STAFF RECOMMENDATION 2519 Blair Boulevard February 21, 2018

Application: New construction – addition; Setback determination; Partial demolition

District: Hillsboro-West End Neighborhood Conservation Zoning Overlay

Description of Project: The applicant proposes to construct a rear addition. The application also includes replacing the center porch post to match the other two existing porch posts, replacing an existing double hung window on the right side façade with a door, and removing the existing second-level door and stairs on the left side façade.

Figure 1: 2519 Blair Boulevard

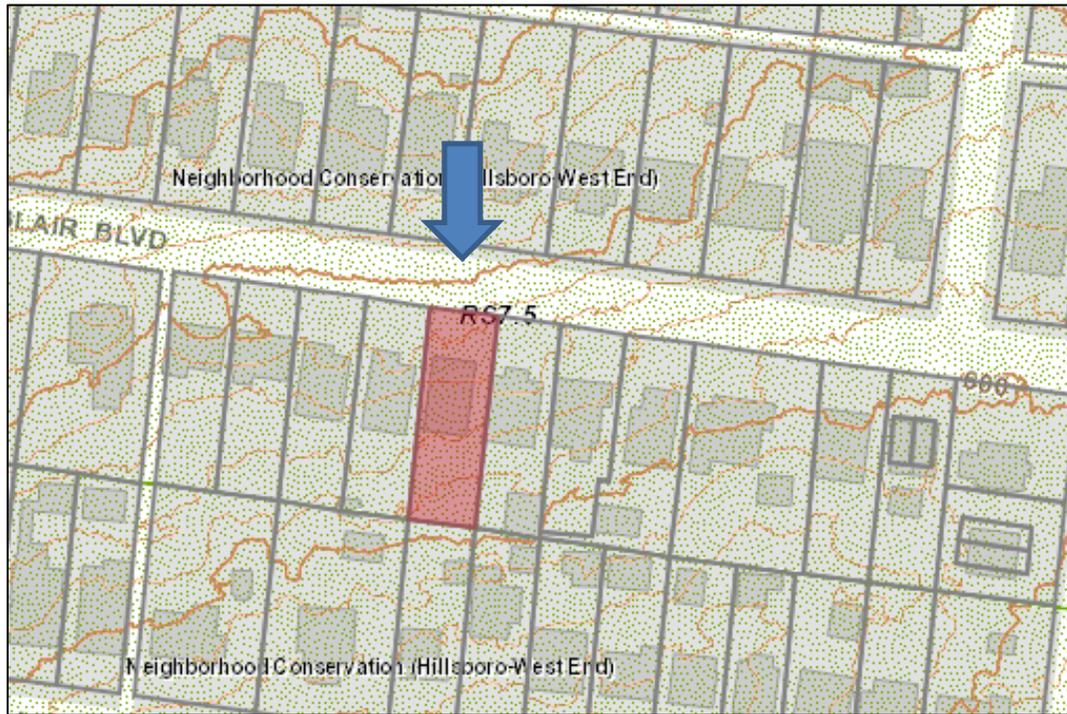
Partial demolition: The application includes replacing the center metal porch post with a new porch column and base to match the other two existing porch posts (Figure 1). Staff finds that this is appropriate as metal porch posts were not typically used during this period of construction and is likely not original to the house.

Figure 2: Existing exterior stairs and second-level door to be removed.

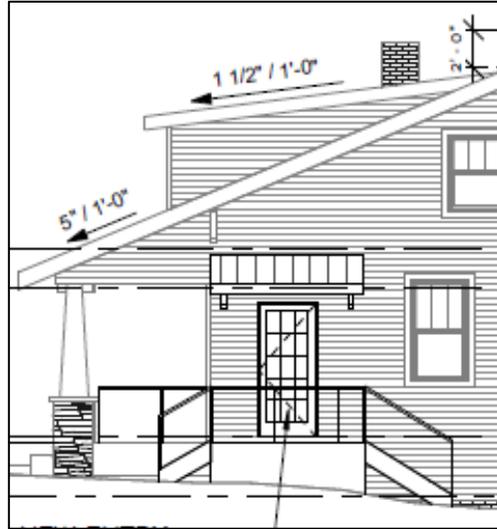
The house is currently a duplex with one unit accessed via exterior stairs to a second-level door (Figure 2). The applicant proposes to remove the existing exterior stairs and second-level door on the left side façade and relocate the second unit access to a proposed side door on the right side façade. To accommodate the proposed side door, the applicant proposes to convert an existing window opening to a door and to install a new metal overhang and walkway to access the entrance (Figures 3 and 4).

The 1931 Sanborn map indicates that the house originally included only one dwelling unit (Figure 5). Since the house was not historically a duplex, the exterior stairs and second-level door are not original, and staff finds that removing those elements is appropriate. Staff also finds that changing the window opening to a door on the right side façade is appropriate since the location and the width of the proposed door opening are similar to that of the existing window. The Commission has permitted roof overhangs that do not include posts to the ground since this type of alteration is removable. For these reasons, staff finds the proposed partial demolition to be appropriate and to meet Section III.B.2 for appropriate demolition and does not meet section III.B.1 for inappropriate demolition.
